Winnebago Industries, Inc. has decided that a safety defect exists on certain vehicles where the roof vent for the optional four-door refrigerator was incorrectly located allowing excessive heat build-up which has the potential to ignite surrounding materials resulting in personal injury and/or vehicle and property damage.

SUBJECT: Campaign #96 –Refrigerator Roof Vent Relocation

Instructions to Perform Campaign 96 Refrigerator Roof Vent Relocation

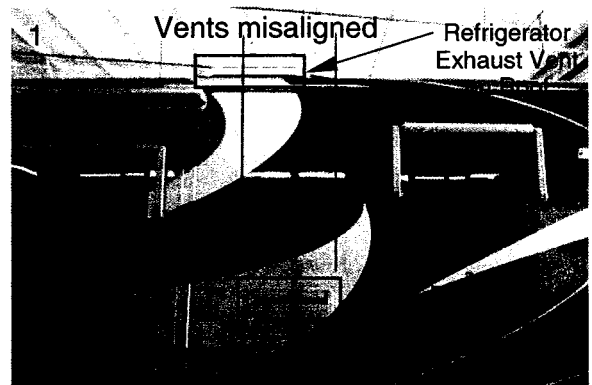
NOTE: Before starting procedure, observe the exterior refrigerator intake and exhaust vents. If the vents are vertically misaligned as shown in photo 1 at right, the roof vent must be relocated as described. If the vents are vertically aligned, no further action is required. (see photo 13 on page 4).

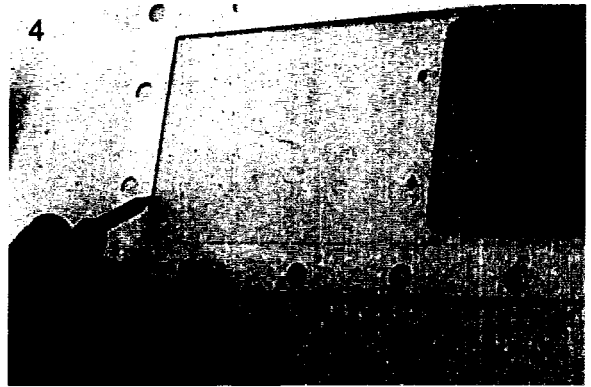
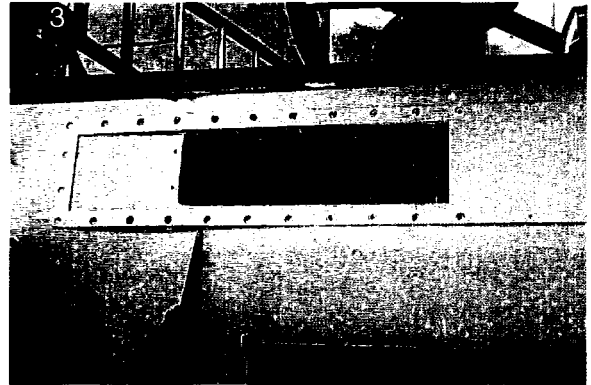
5. Place the cover plate into position to use as a template to mark the area to be cutout. (photos 3 and 4)

Important: Be sure the new cutout area will be located above the refrigerator exhaust flue tube.

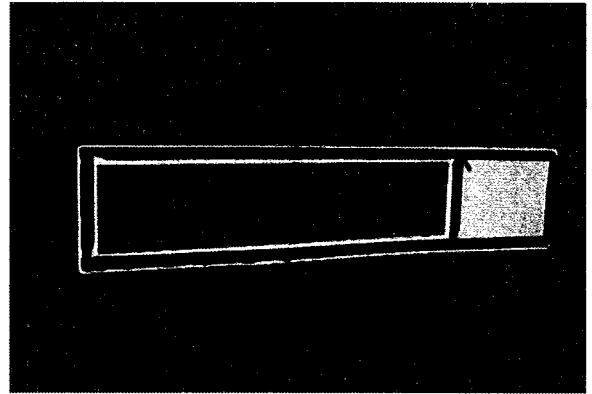
7. Use a reciprocating saw to enlarge the opening. The cutout will provide an additional 200 mm for the opening. (photo 5)

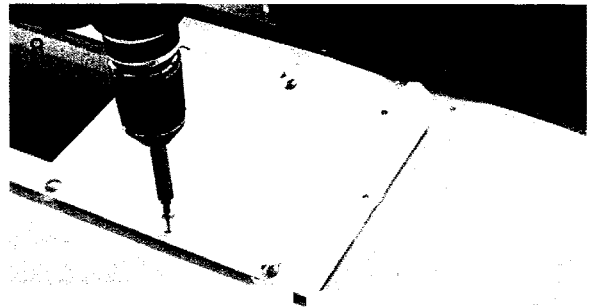
9. Be sure installation of the refrigerator flue deflector is level as shown in photo 6. Reposition if necessary.

10. Apply butyl tape to bottom of cover plate as shown in photo 7.

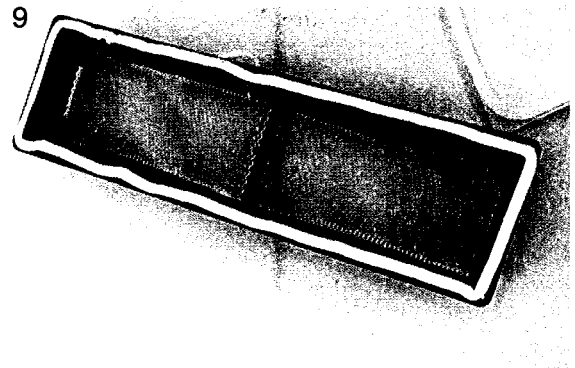
11. Position the cover plate so that the open area is above the refrigerator flue tube, then fasten the "solid" part of the plate to the roof with 5 pan head screws #8 x 3/4" (photo 8). The larger 1/2-inch holes in the cover plate should line up with the existing screw holes in the fiberglass from the original installation.

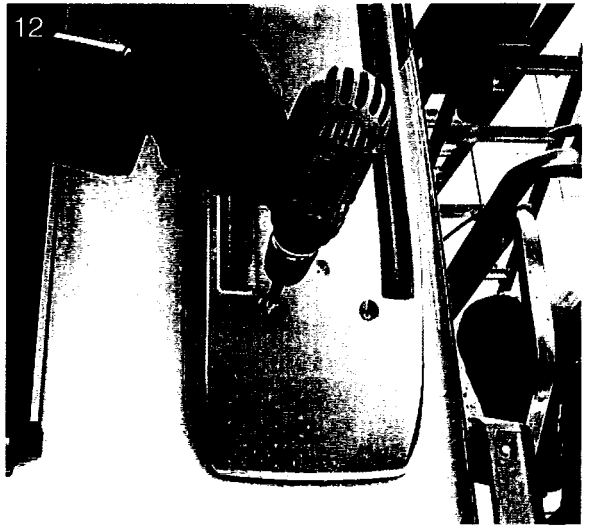
12. Clean sealant from the roof vent and apply new butyl tape. (photo 9) Install the refrigerator vent so that the word "FRONT" (marked on the vent) faces the front of the vehicle. Reconnect the solar panel wiring (if equipped) and refasten the vent with existing screws removed in step 3.

13. Wipe the vent flange and screw surfaces with isopropyl alcohol (photo 10) then apply self-leveling RTV silicone sealant liberally to screws and edges around perimeter of vent and cover plate (photo 11).

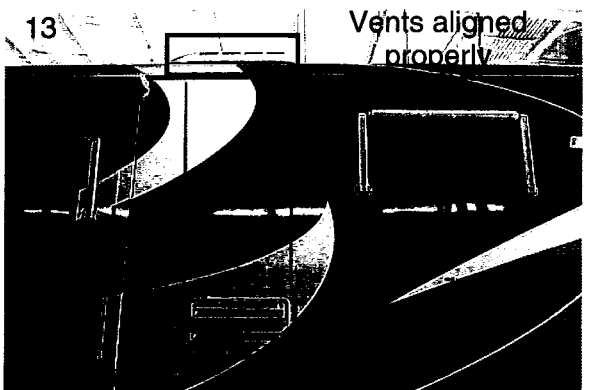
14. Install roof vent cover. (photo12)

15. Roof vent and side intake should now be aligned as shown (photo 13).
